Access Compliance Report Public Rights-of-Way (Curb Ramps)

Intersection ID: 50934 Main Street: KNOWLEDGE CR **Cross Street: SCHOLASTIC DR** Location: NW **ADA ID: 1E678D22AC2F** Ramp Type: PerpDiag Initial Pass/Fail: Fail **Overall Compliance: No** Severity Score: 33.75

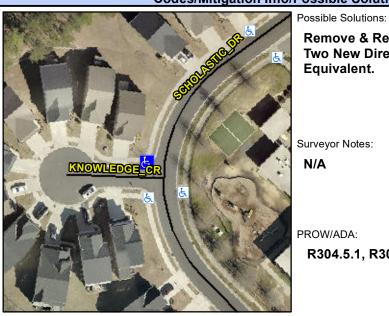
Field Measurements/Component Compliance							
	Compliance Description		Data	Compliance		Description	Data
	N/A	Ramp Length (in)	46.0	No	Ram	Slope (%)	12.3
	No	Ramp Width (in)	47.0	Yes	Ramp	XSlope (%)	1.4
	N/A	Flare Type LT	N/A	N/A	Flare	Type RT	N/A
	N/A	Flare Slope LT (%)	N/A	N/A	Flare	Slope RT (%)	N/A
	N/A	Flare Traversable LT?	N/A	N/A	Flare	Traversable RT?	N/A
	N/A	Landing Length (in)	N/A	N/A	DWS	Provided?	N/A
	N/A	Landing Width (in)	N/A	N/A	DWS	Contrast?	N/A
	N/A	Landing Slope (%)	N/A	N/A	DWS	Length (in)	N/A
	N/A	Landing X Slope (%)	N/A	N/A	DWS	Full Width?	N/A
	N/A	Landing Curb? (Y/N)	N/A	N/A	DWS	Offset (in)	N/A
	N/A	Shared Landing?	N/A				
	N/A	Gutter Ponding?	N/A	N/A	Gutte	er Slope (%)	N/A
	N/A	Gutter Lip Ht (in)	N/A	N/A	Gutte	er X Slope (%)	N/A
	N/A	Painted X Walk1?	No	N/A	Paint	ed X Walk2?	No
		X Walk 1 Direction	To S		X Wa	lk 2 Direction	To E
	N/A	X Walk 1 Width (in)	N/A	N/A	X Wa	lk 2 Width (in)	N/A

X Walk 1 Slope (%)	1.0		X Wa	lk 2 Slope (%)	1.0
		X Walk 1 X Slope (%)	0.1		X Wa	lk 2 X Slope (%)	0.2
	N/A	Ramp inside XWalk1?	N/A	N/A	Ram	o inside XWalk2?	N/A
		Road Slope (%)	0.9	N/A	Clear	Space?	N/A
		Road X Slope (%)	0.5	N/A	Clear	Space to XWalk (in)	N/A
	N/A	Any Obstructions?	N/A	N/A	Storn	n Grate/Utility Hazard?	N/A
		Obstruction Type			Storn	n Grate/Utility Type	
			N/A				N/A
				Yes	Surfa	ce Condition? (G/P)	Good

Remove & Replace Curb Ramp With Two New Directional Ramps or Equivalent.

R304.5.1, R304.2.2
